PLANNING AND DEVELOPMENT SERVICES STAFF REPORT

For Planning Commission Meeting of October 20, 2015

**SUBJECT: 2250 Ann Arbor-Saline Road Site Plan and Wetland Use Permit for City Council Approval
(2250 Ann Arbor-Saline Road)
File Nos. SP14-023 & WUP15-001**

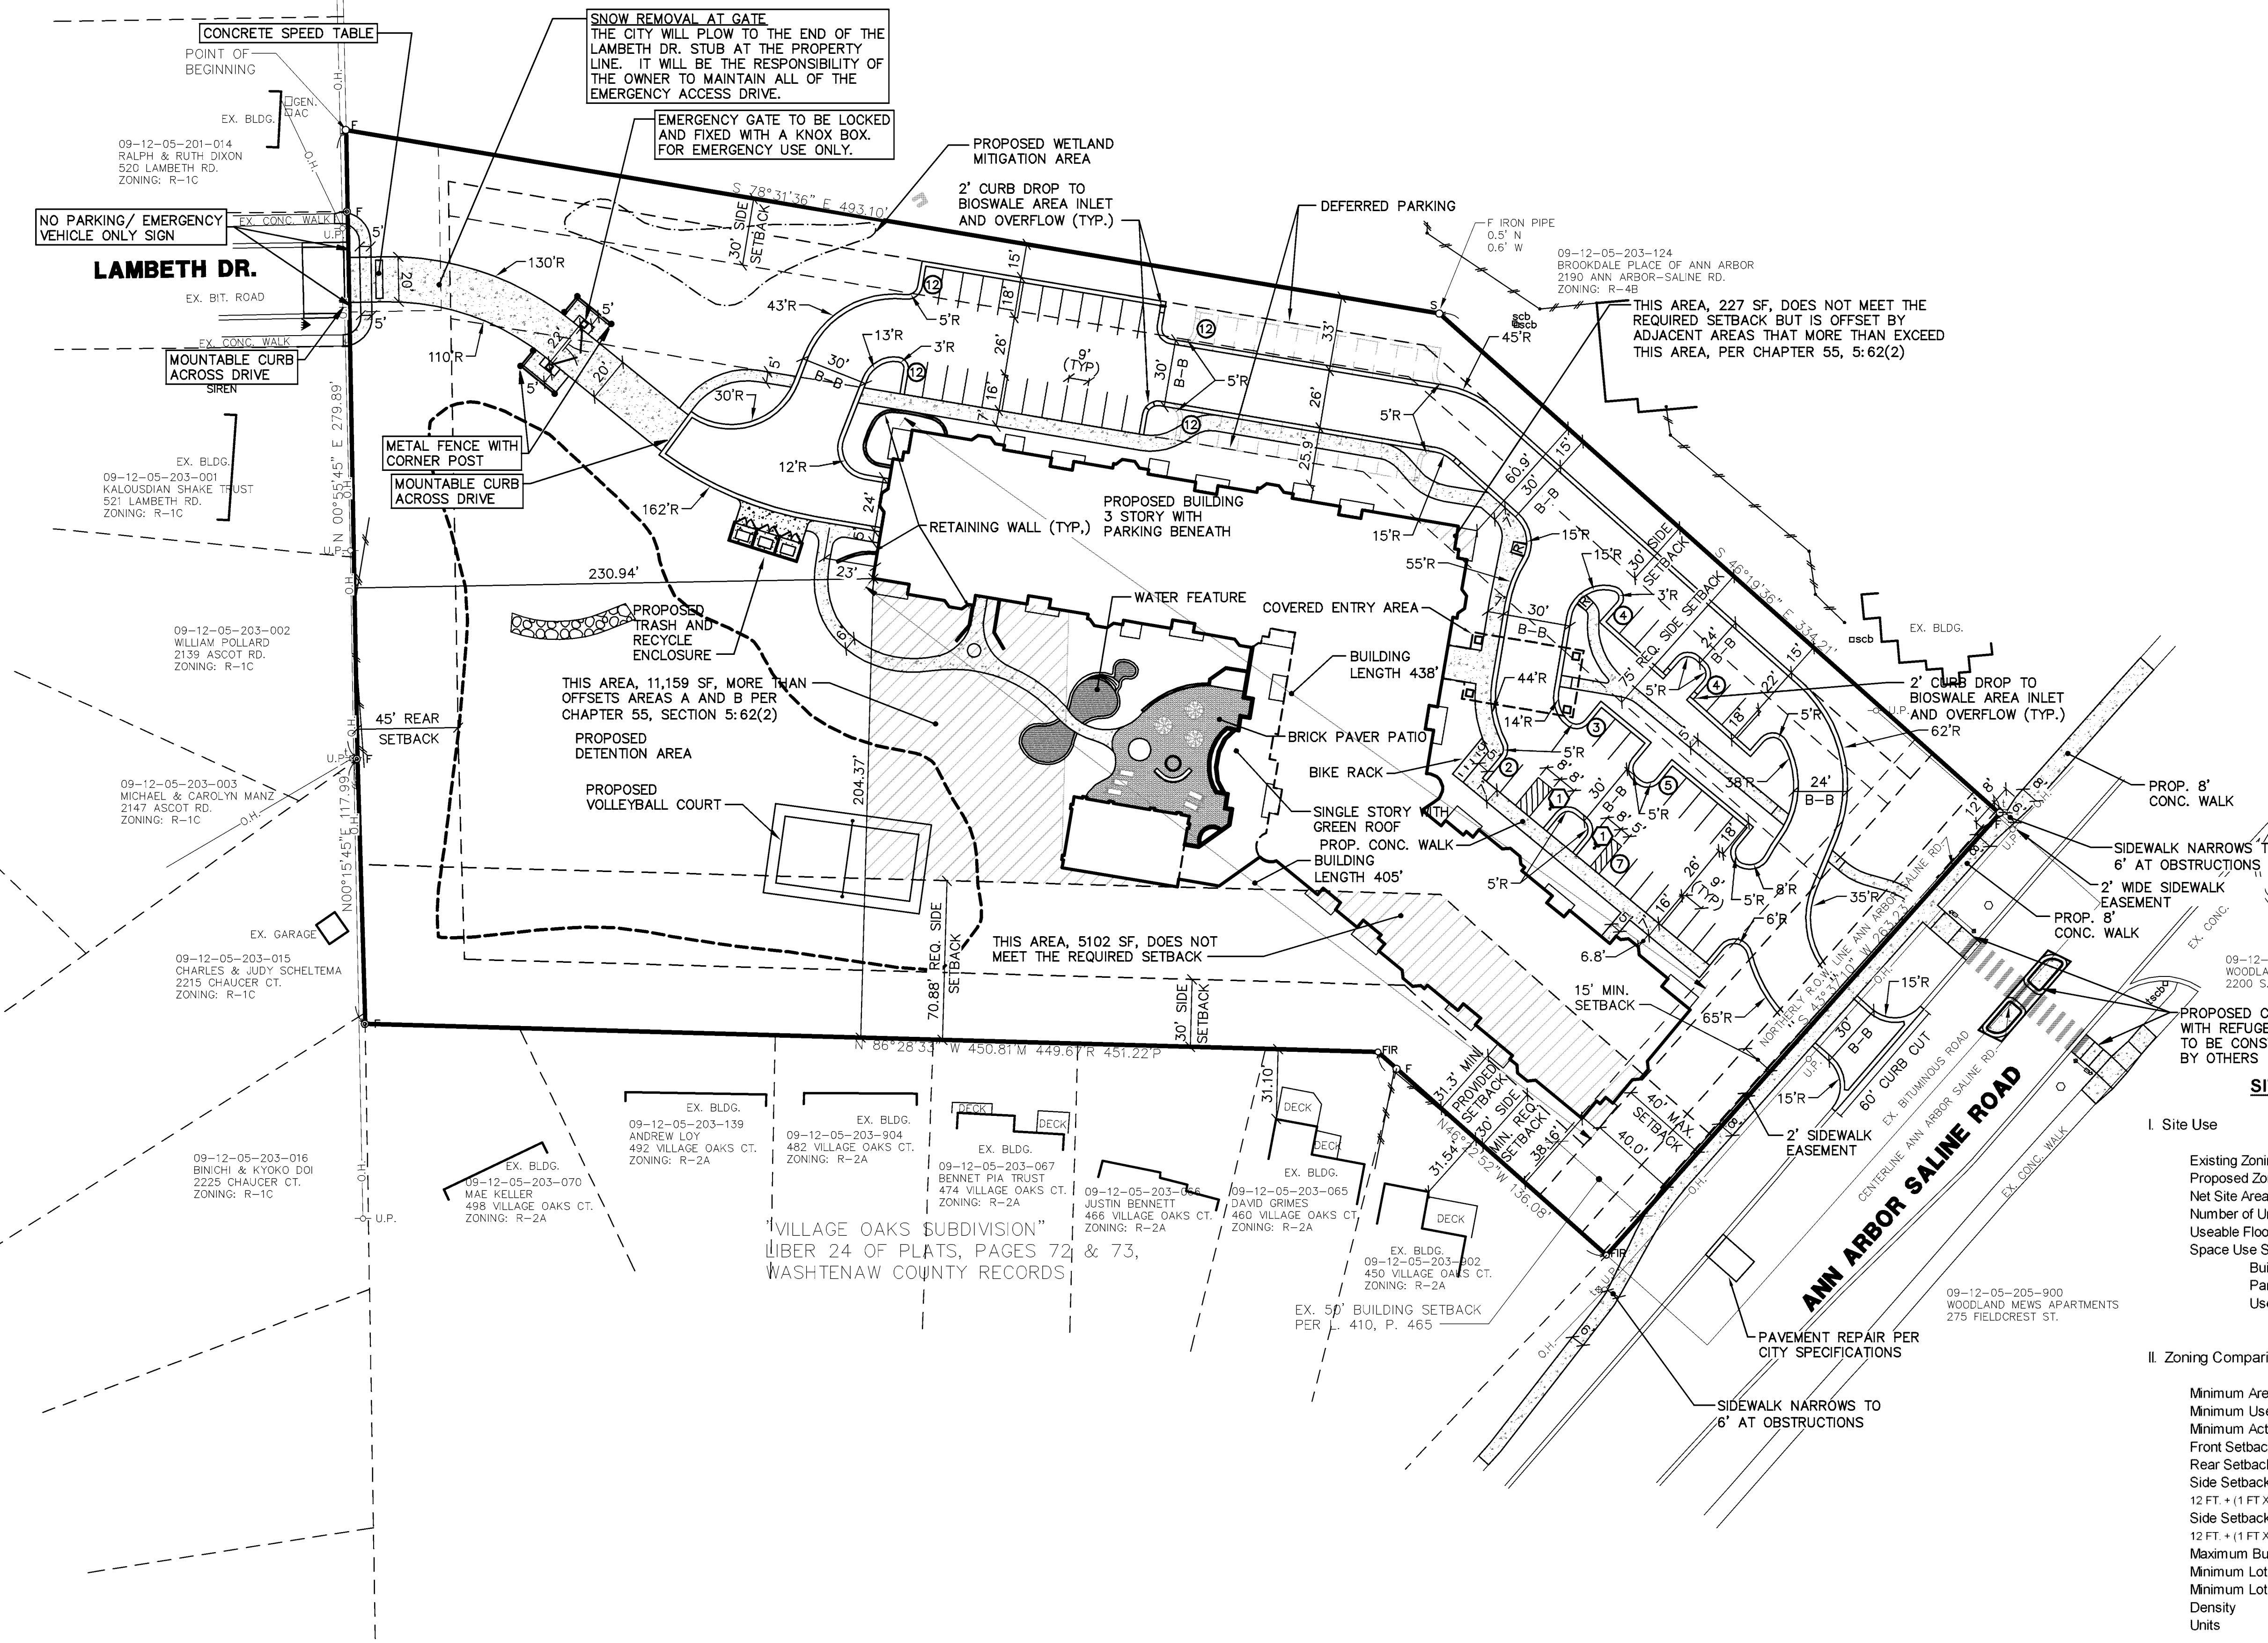
Access to Lambeth Drive – Planning Commission expressed concern about the previously proposed emergency-only gated connection to the adjacent neighborhood using the existing Lambeth Drive stub street, but indicated general support for the concept of the emergency access only drive. The petitioner has responded by converting the former 30 foot wide asphalt drive with sidewalks on both sides to a 20 foot wide concrete path, similar to an extra-wide sidewalk as suggested by Planning Commission. The path will have a rolled curb at both ends, sidewalks that 'carry through' the path at the Lambeth terminus and a concrete speed table to further delineate the path from a standard drive.

Parking – Planning Commission expressed concern about the number of surface parking spaces provided on the site. The petitioner has agreed to defer 24 surface parking spaces near the northeast corner of the building. These spaces will be shown on the site plan as deferred, but storm water and landscaping calculations are reviewed as if the parking will be installed. Chapter 59 (Off-Street Parking) allows that if the Planning and Development Services Manager or designee determines that the parking is needed, the spaces must be installed. There will be no Planning Commission approval required if the spaces are installed in the future.

The path will still have a locked gate for emergency access only, but will have a pedestrian sidewalk bypass around the locked gate with a metal fence adjacent to prevent vehicular use. The gate will remain locked with a Knox Box for use by emergency services only. Residents of the development will not have a key, only the fire department. The locked gate will be shown on the approved site plan and removal of the gate for facilitation of general public access will be a violation of the site plan and enforceable against the property owner. This requirement will also be listed in the site development agreement, which is a legally binding document between the City and the property owner.

The Fire Marshall has reviewed and approved the revised emergency access drive plan.

2250 ANN ARBOR-SALINE ROAD
SITE PLAN
LANDSCAPE PLAN

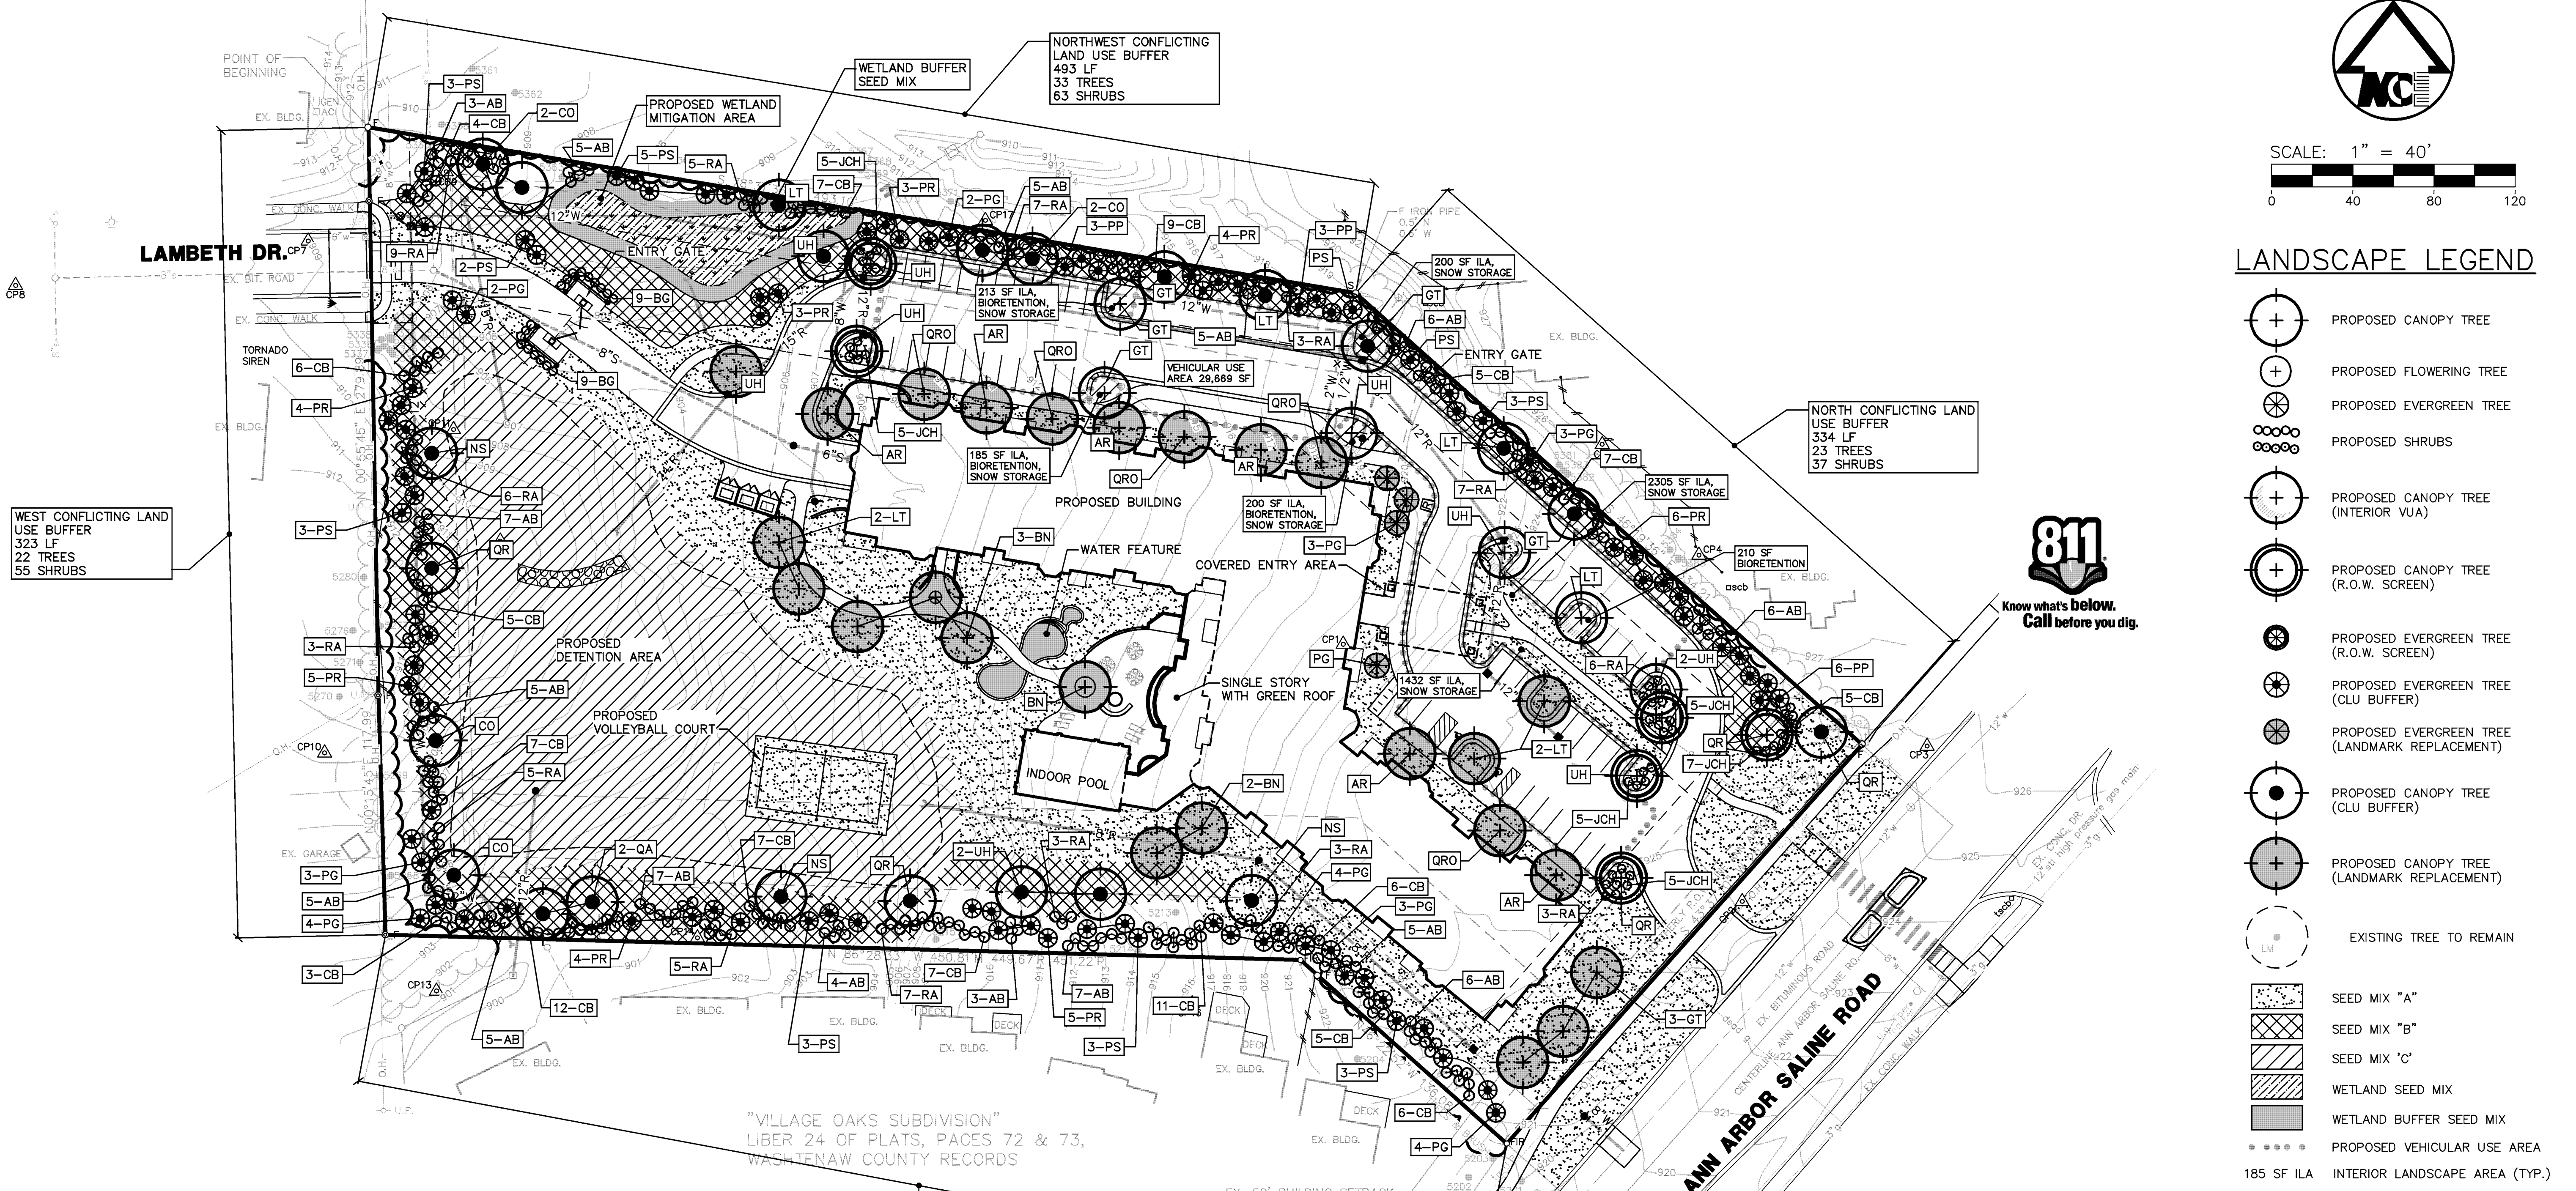
Landscaping – Planning Commission asked about additional landscaping in order to help buffer the building, particularly along the southeastern corner of the site. The petitioner has doubled the amount of evergreen trees and landscaping along the south eastern parcel line closest to the adjacent residential structures. Additional evergreen trees have also been planted along the western edge of the property near the terminus of Lambeth.
